INSERVICE TESTING PLAN

REVISION 11

SAN ONOFRE NUCLEAR GENERATING STATION

UNIT 2

FIG. IWB-2500-11 PIPE BRANCH CONNECTION

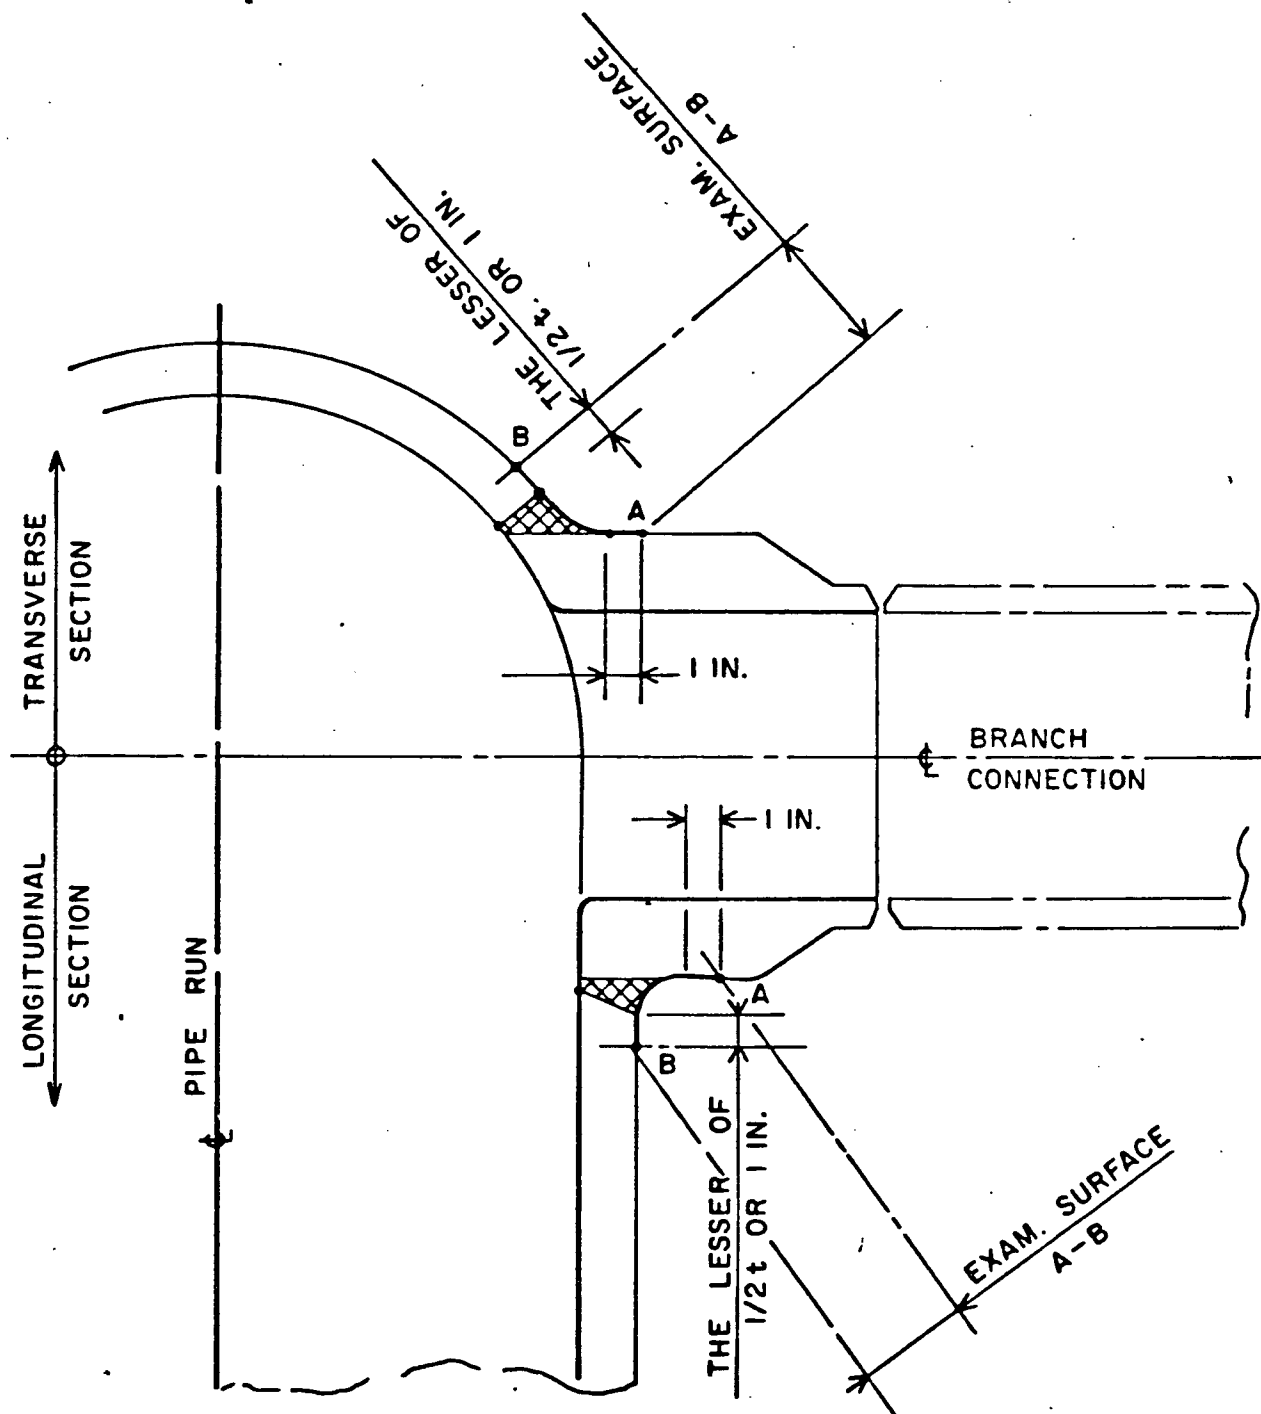
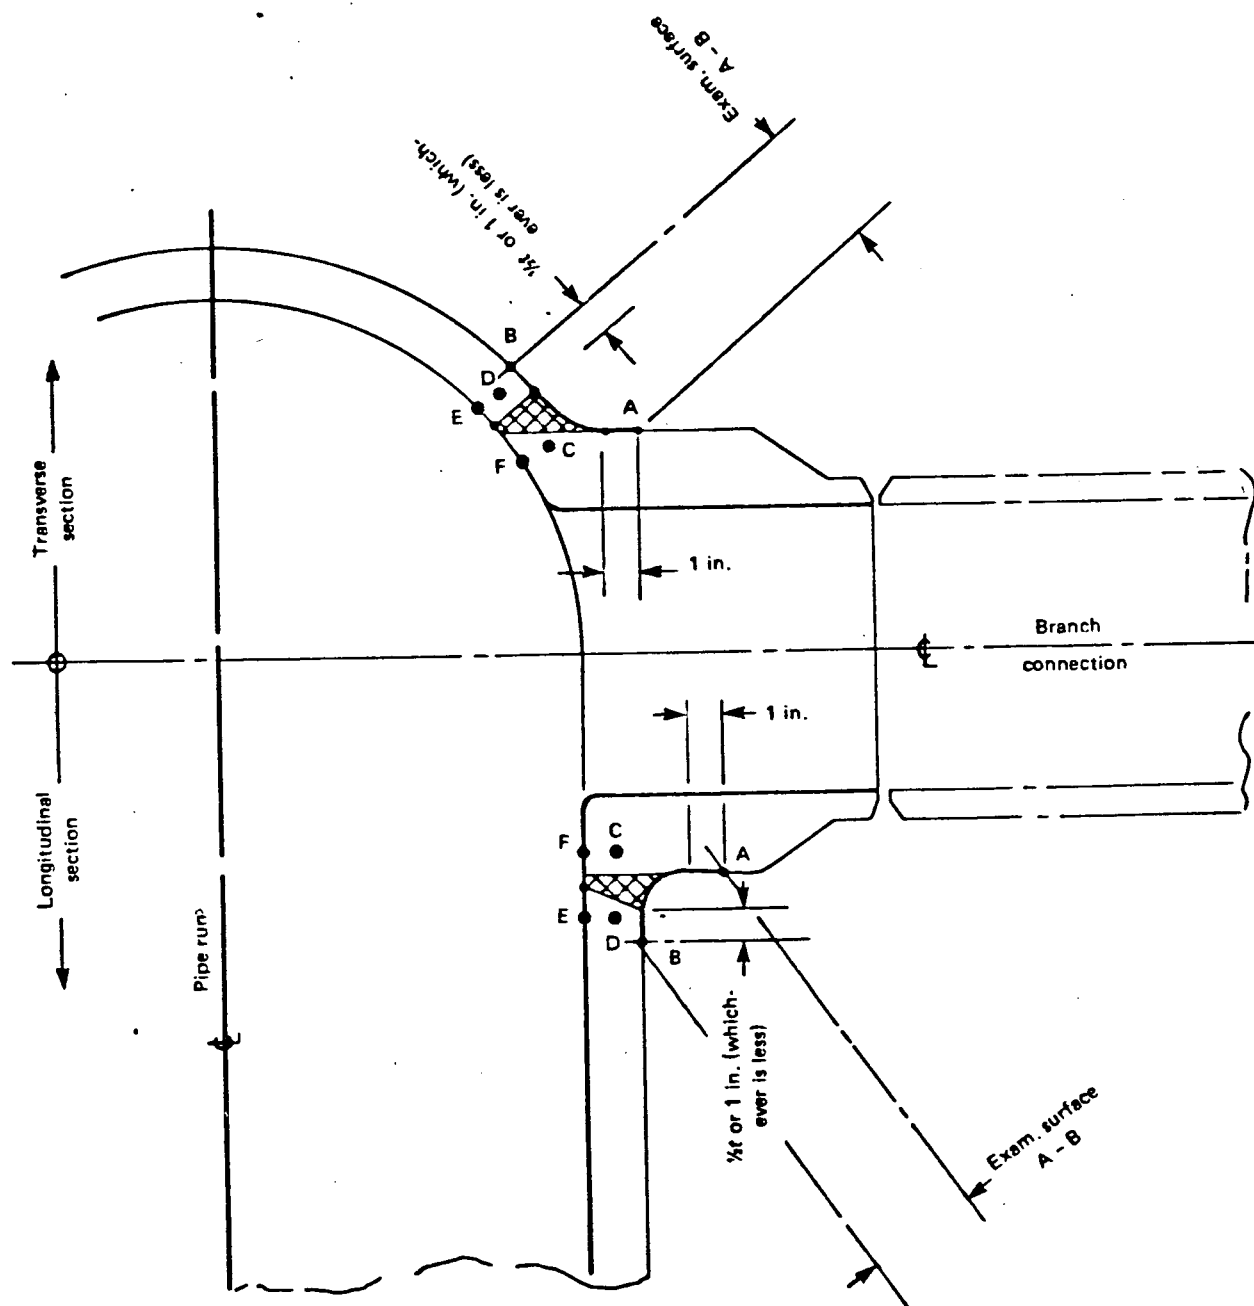
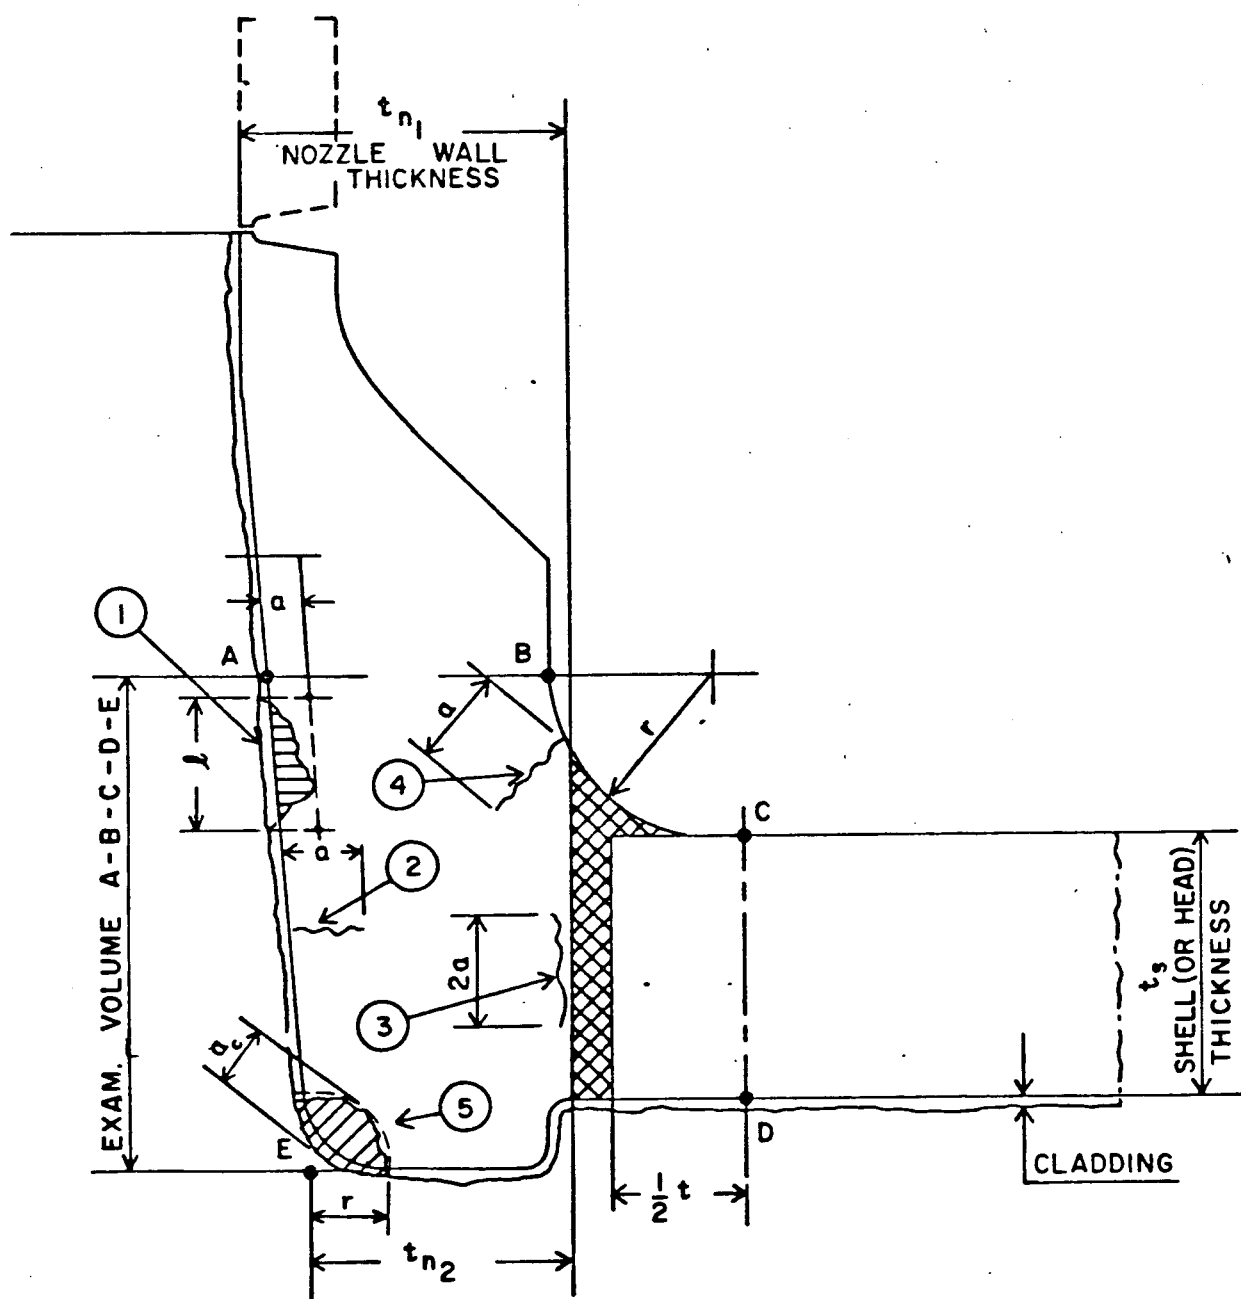
Item B9.31 requires surface and volumetric examination of branch pipe connection welds in accordance with Figures IWB-2500-9, 10, and 11. Figure 11 (attached) depicts branch connection welds used for SONGS-2 reactor coolant piping connections. Figure IWB-2500-11, page 15, does not define examination volume, but specifies examination surface only (A-B).

FIG. IWB-2500-7 NOZZLE-TO-SHELL OR HEAD WELD JOINTS
(Applies to Nozzles With or Without Internal Reinforcement)

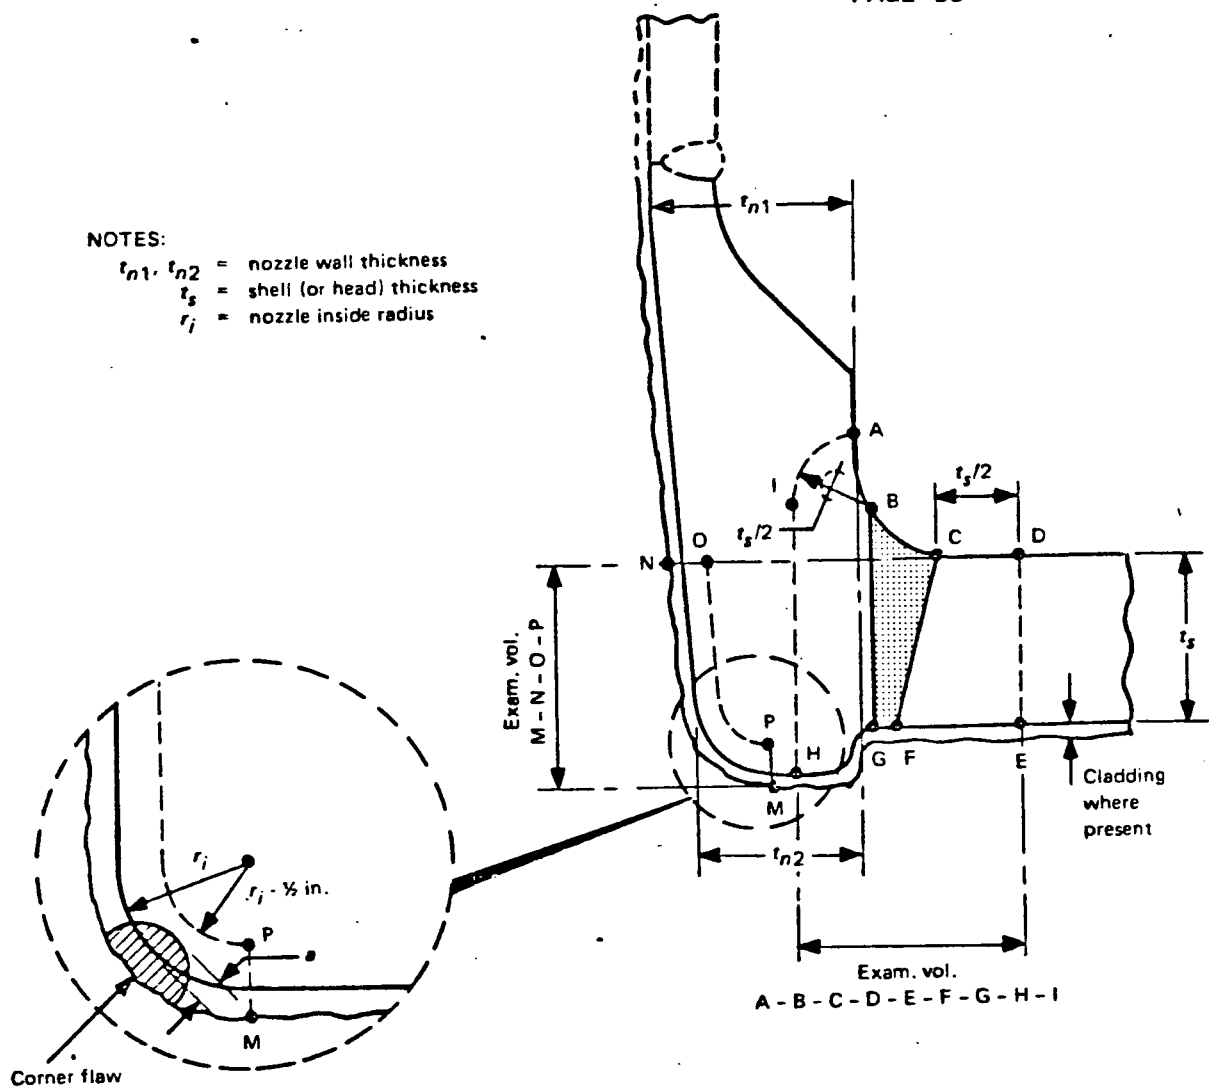
Items B3.110 and B3.130 require volumetric examination of Pressurizer and Steam Generator nozzle-to-vessel welds and adjacent areas of (the) nozzle and vessel in accordance with Figure IWB-2500-7 (attached). Examination volume A-B-C-D-E is well-defined.

Relief is requested to allow examination of the weld volume A-B-C-D-E-F-G-H-I as defined in Figure IWB-2500-7(a) of the Winter 1980 Addenda of the Code (also attached). Category Items B3.120 and B3.140 examinations of the nozzle inside radius section will include volume M-N-O-P as defined in attached Figure IWB-2500-7(a). The volumes defined in Figure IWB-2500-7(a) contain the high stress regions and heat-affected zones which are of concern for the long term operation of the components.

FIG. IWC-2520-3 NOZZLE-TO-VESSEL WELDS

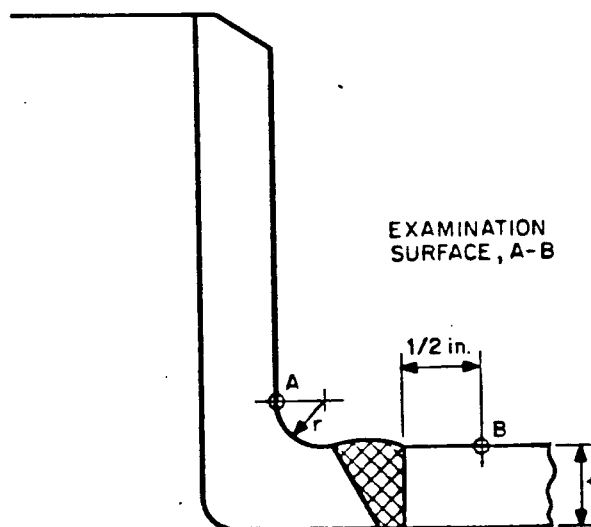
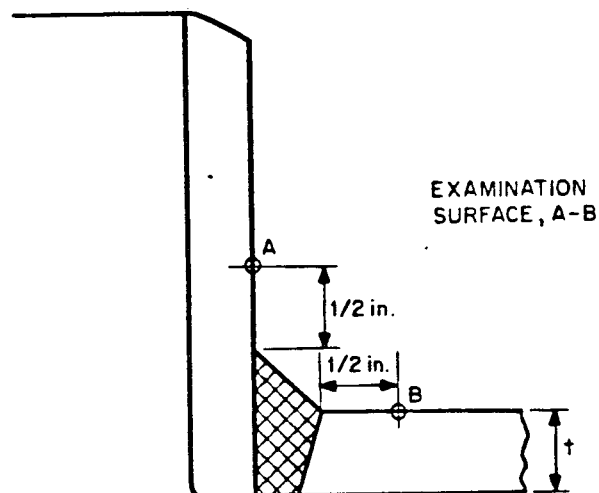
Item C2.10 requires a surface examination of nozzle-in-vessel welds 1/2 inch thick or less in accordance with Figure IWC-2520-3.

Figures IWC-2520-3 and IWC-2520-4 are attached. They do not show welds with reinforcing saddles.

Relief is requested from the above requirements for nozzles with reinforcing saddles since the nozzle-to-vessel welds are not accessible for surface or volumetric examination. A surface examination of the fillet welds attaching the saddle-to-vessel and saddle-to-nozzle will be conducted as an alternate examination (see attached Figure 6.3-1).

FIG. IWC-2520-4 NOZZLE-TO-VESSEL WELDS

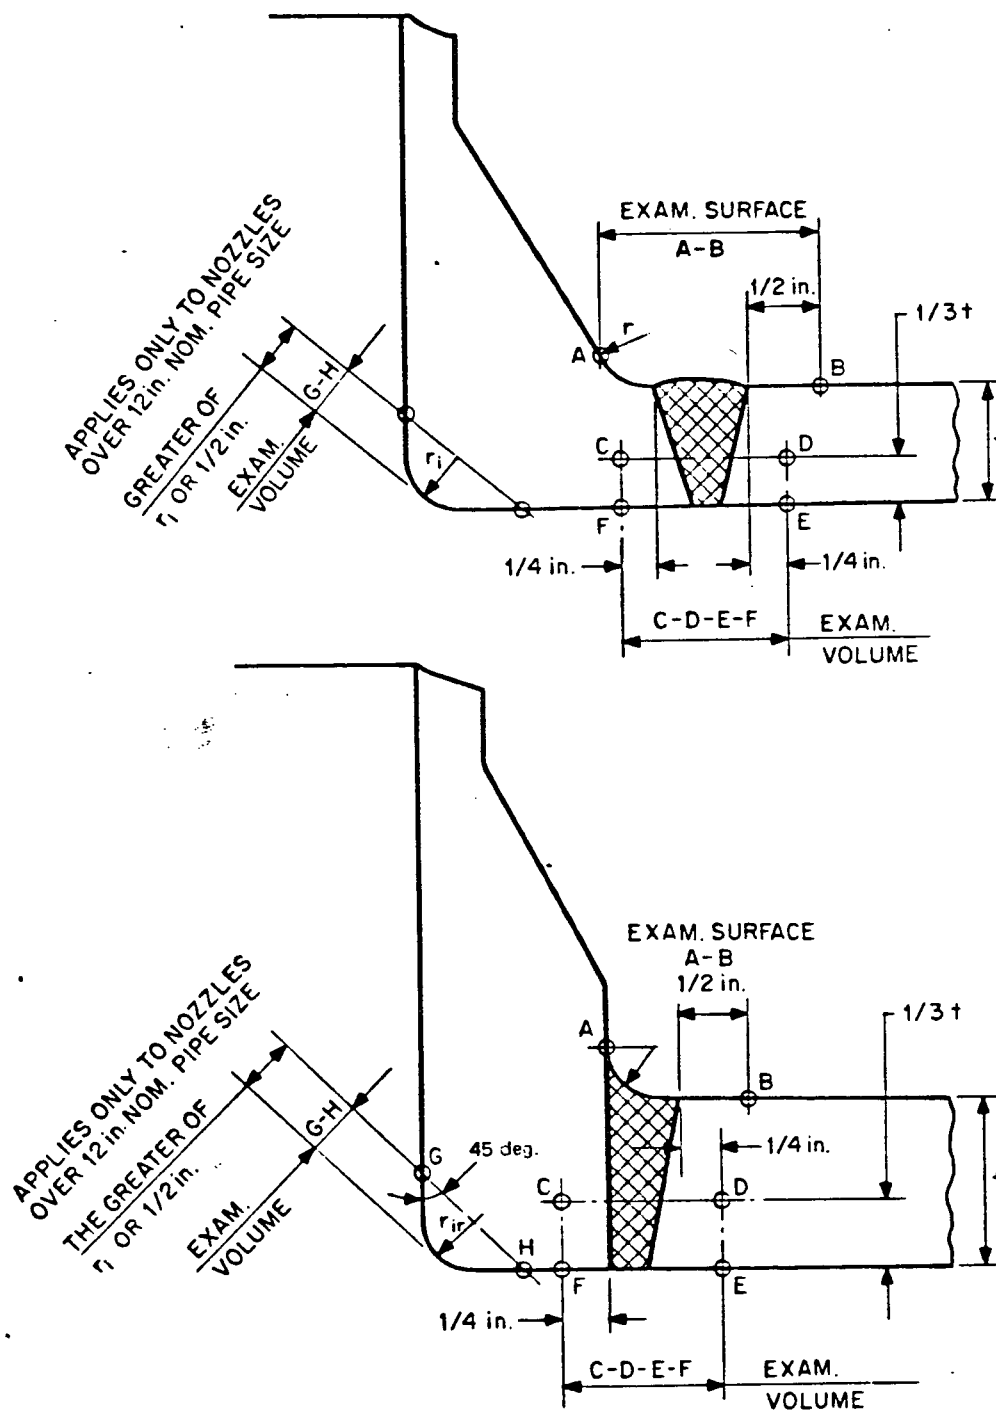
Item C2.20 requires a surface and volumetric examination of nozzle-in-vessel welds over 1/2 inch thick in accordance with Figure IWC-2520-4.

Relief is requested to allow volumetric examination of Steam Generator Secondary Side nozzle-to-vessel welds from the shell side only, as shown in attached Figure IWC-2520-4. This examination will include volume C-D-E-F and as much of volume G-H as is practical. Preservice examination was conducted from the shell side only due to restricted access from the nozzle forging side as a result of weld and nozzle configuration.
